## Planning Commission Agenda

- 2. THE MATTER OF THE PROPOSED PRELIMINARY SUBDIVISION PLAT FOR SOMMERVILLE MEADOWS LOCATED AT 915 SOMMERVILLE LOOP.**

# Staff Report Harrisburg Planning Commission Harrisburg, Oregon

DATE: 8/13/24  
SHEET C2

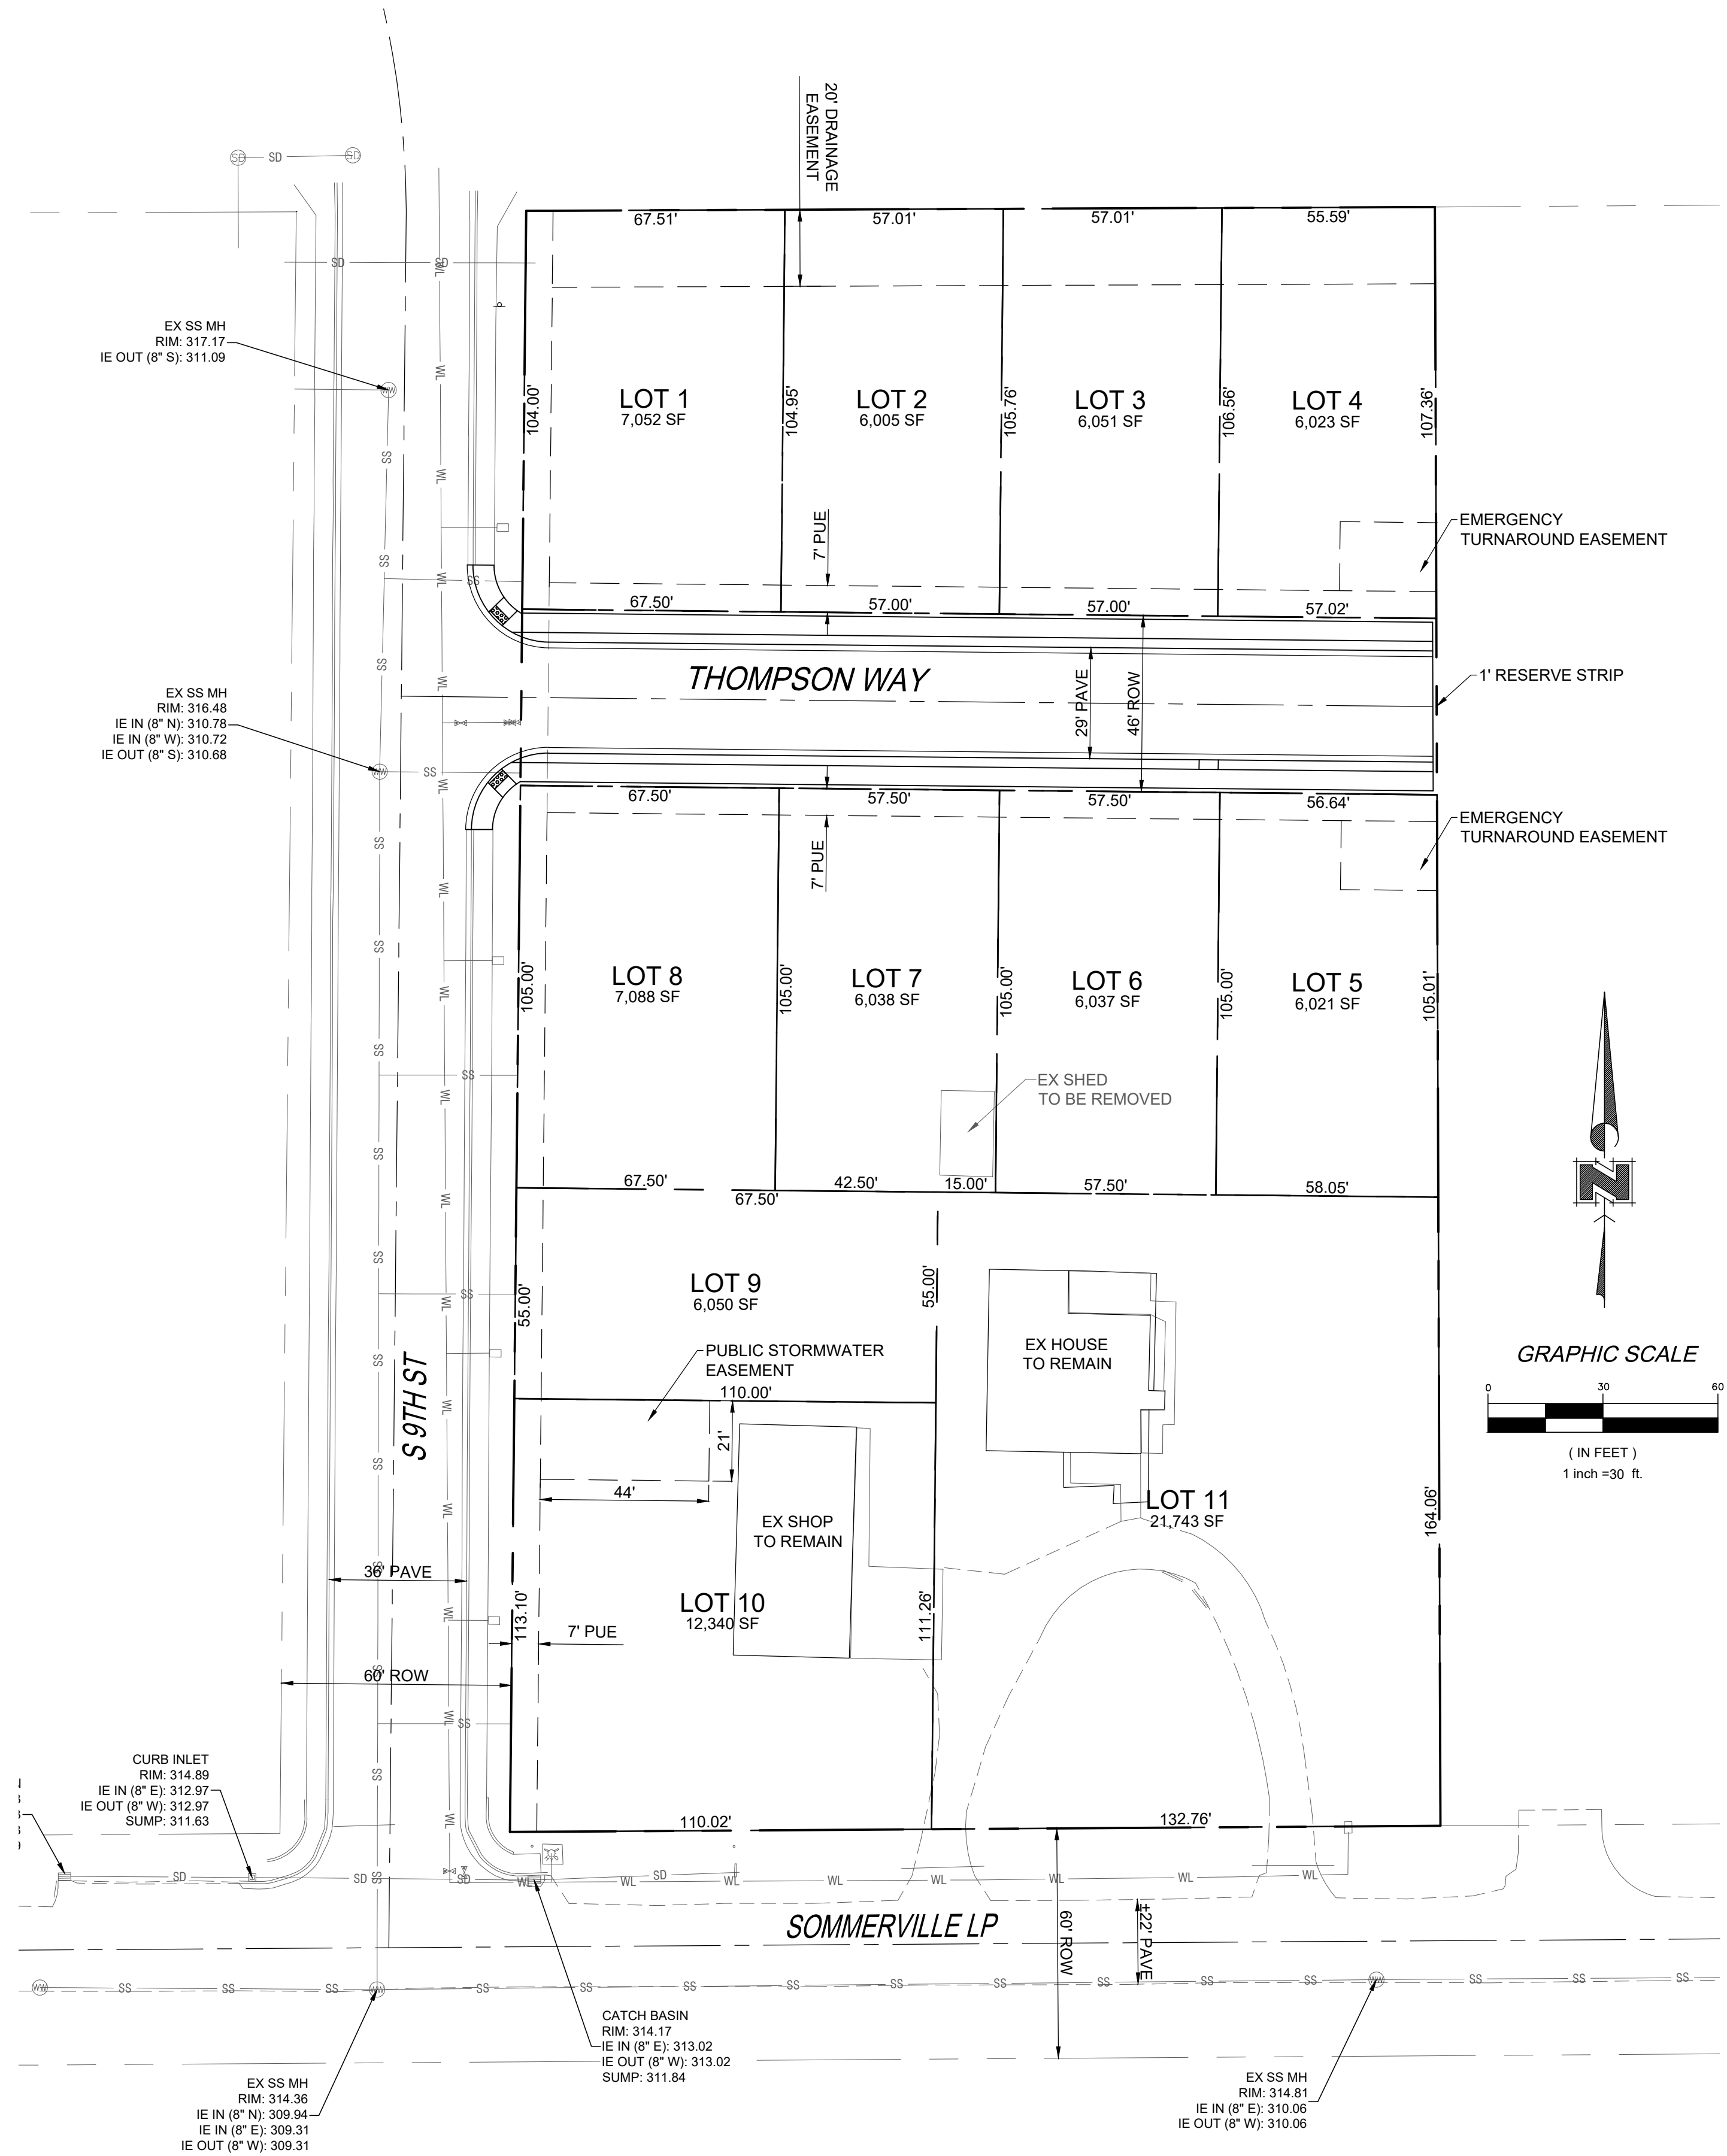
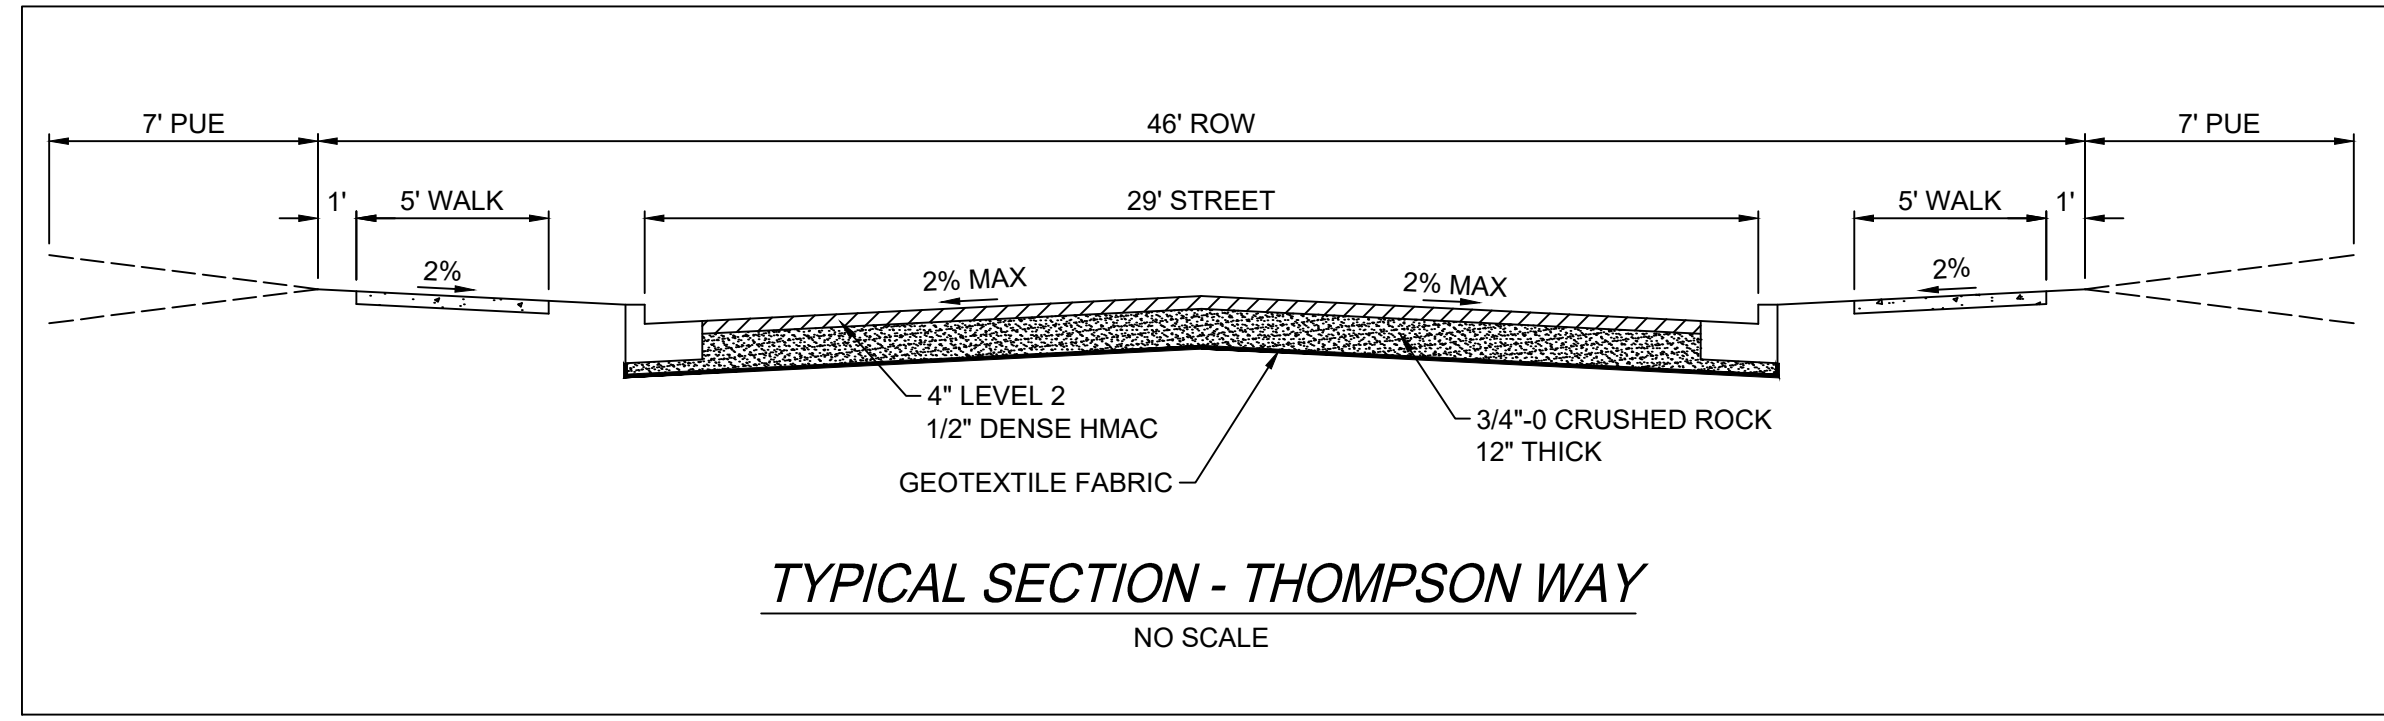
**RECOMMENDED CONDITION NO. 6:** The developer has shown an emergency turnaround easement on Lots No. 4 and 5. These easements must be paved, and be able to withstand 75,000 lbs. of emergency vehicle. The deed for lots 4 and 5 should state that the homeowners are not allowed to park on these approaches, but may use them as a driveway to the back of their property, or to a gravel pad used to store a RV. The developer shall add a small sign to the landscaping in this area at the time that the building permit is issued that states no parking in this area.

**DISCUSSION:** The Applicant didn't address HMC 18.75 in their narrative, but landscaping, fences, and walls will apply to the proposed public stormwater easement located on Lot. No. 10. The drawing shown on Page 36 of the application packet, shows a sand filter detention system that will not be allowed by the City Engineer. The applicants engineer will need to provide the City with schematics for a different system, which will traditionally require plantings, as well as a fence surrounding it. This detail will be provided with the Civil Engineering documents addressed further in this staff report.

**RECOMMENDED CONDITION NO. 7:** The applicant shall provide the City with a plan for a fence, and plantings for a standard detention pond as required by the City Engineer in the detail provided in the public improvements plan set. (Civil Engineering)

DATE: 8/13/24  
 SHEET C3

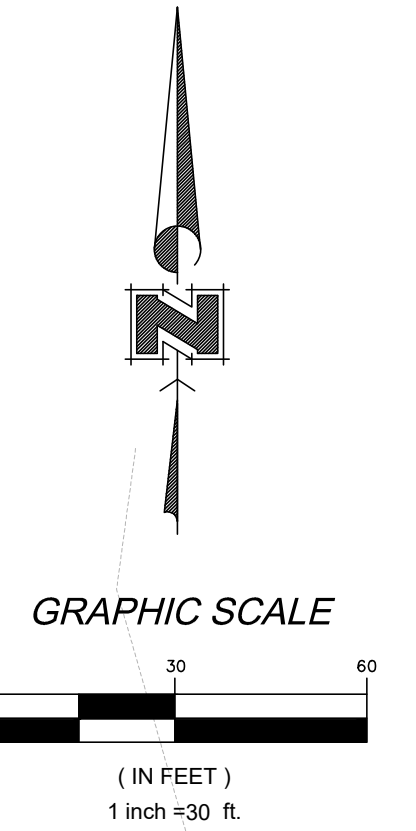
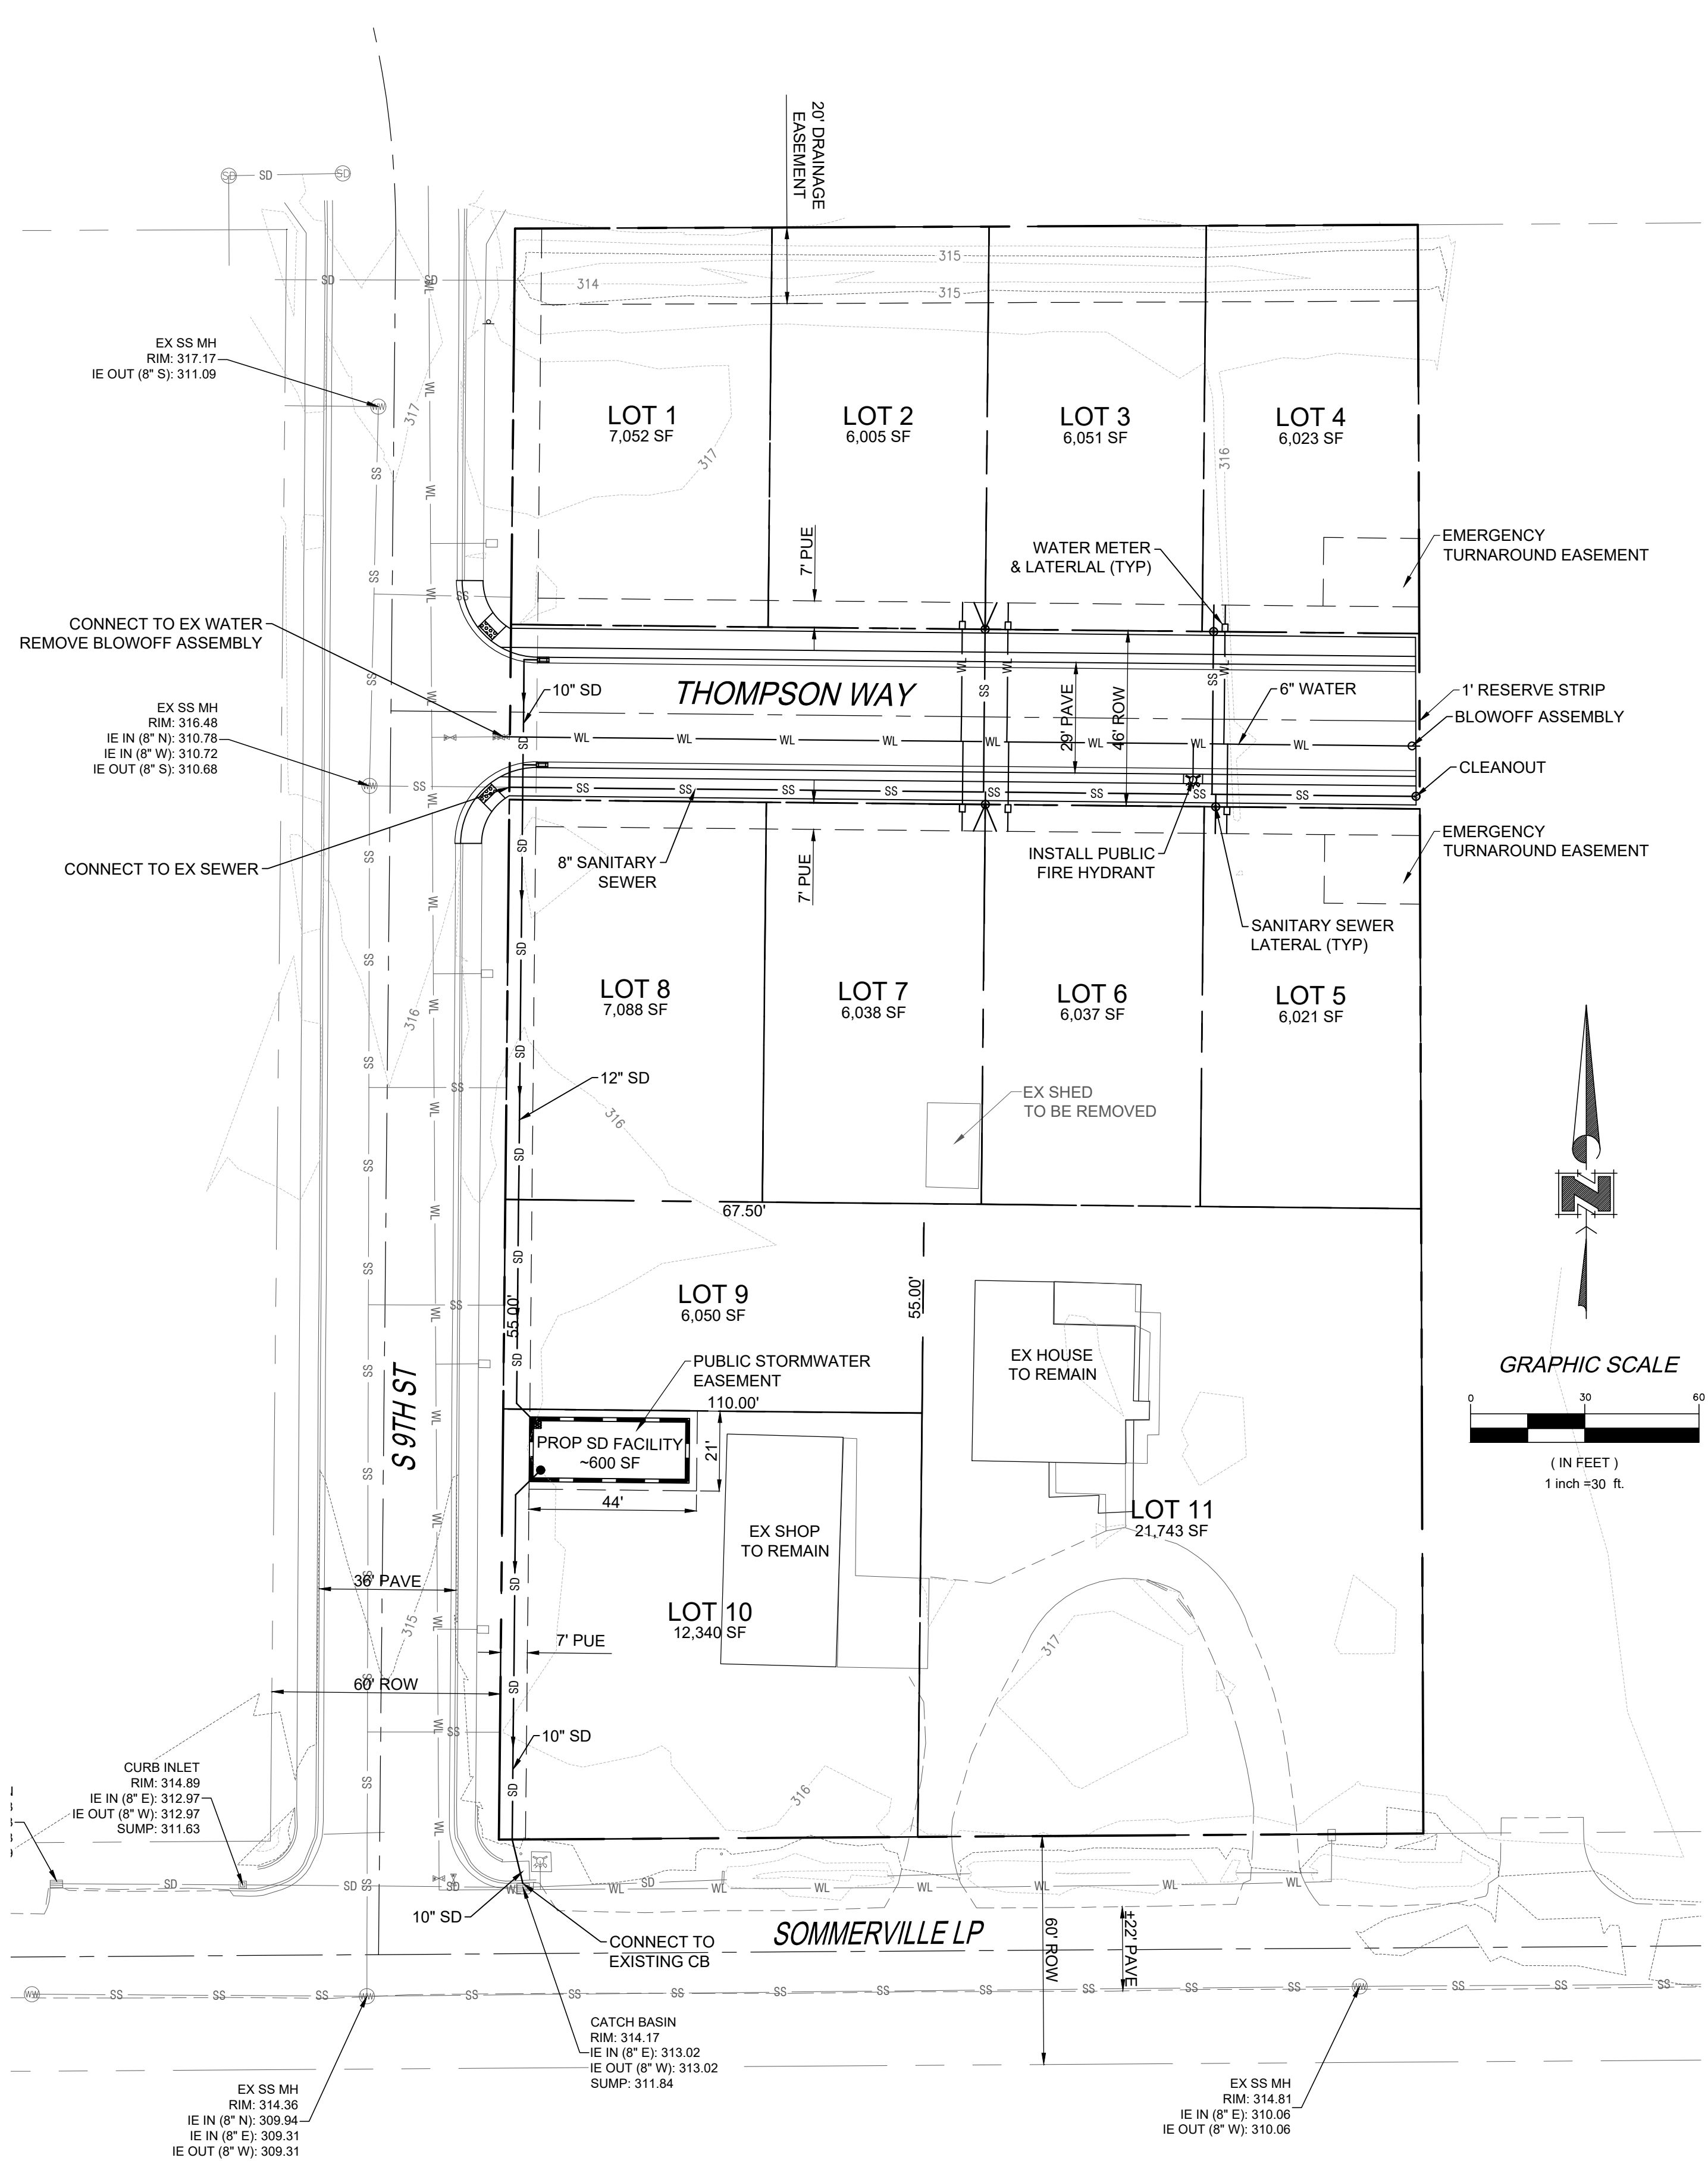
**DISCUSSION:** The proposed Preliminary Subdivision includes one new intersection. This is a 3-legged intersection with the intersecting streets aligned at generally 90-degree angles. Thompson Way will be a dead-end street. Because there is possible development that can occur on the eastern properties, the developer will be required to provide the City with a reserve strip tract in the final plat process. This is shown on page 36 of the applicants packet, sheet C3.

**DISCUSSION:** The Applicant has proposed a stormwater management plan that includes on-site drainage for the street, with an additional storm detention system which will be located on Lot. No. 10. (See Tentative Composite Utility Plan, on page 36 of the applicant’s packet). The application materials also include a 25-year Storm Plan, starting on page 6 of the application packet, which has been prepared by a licensed professional engineer.

In addition, the City Engineer has indicated that the roof drainage of new homes should be piped to the storm system through weepholes in the curbs, and should be detained in the proposed detention system. He has also asked that a detailed site grading plan demonstrating drainage patterns including rear yards be submitted. This will help in working with the 20’ drainage easement located on the north of the lots abutting the Max Hammer subdivision.

**DISCUSSION:** The Applicant proposes to place all utilities underground in compliance with the criterion. The Utility Plan (Pg 36, Sheet C3 of the applicant’s packet) does not provide information on utilities, beyond those utilities previously listed (water, sewer, stormwater) or the location of surface-mounted facilities.

**RECOMMENDED CONDITION NO. 10:** The applicant will be required to provide the City with a reserve strip as a separate tract in the final plat. This detail shall be required to be shown in the civil engineering set of plans that the City Engineer will approve.

**RECOMMENDED CONDITION NO. 13:** The applicant shall provide and show that the roof drainage for future homes should be piped to the storm system through weepholes in the curbs, and should be detained in the storm detention system. The applicant must also work with the City Engineer to determine a

different detention device, such as a storm detention pond, that can be used for storage of storm water. As previously conditioned, the stormwater detention area will need to be landscaped, and fenced. All changes shall be reviewed and approved by the City Engineer, and will be shown on the privately engineered public improvement construction plans and specifications.
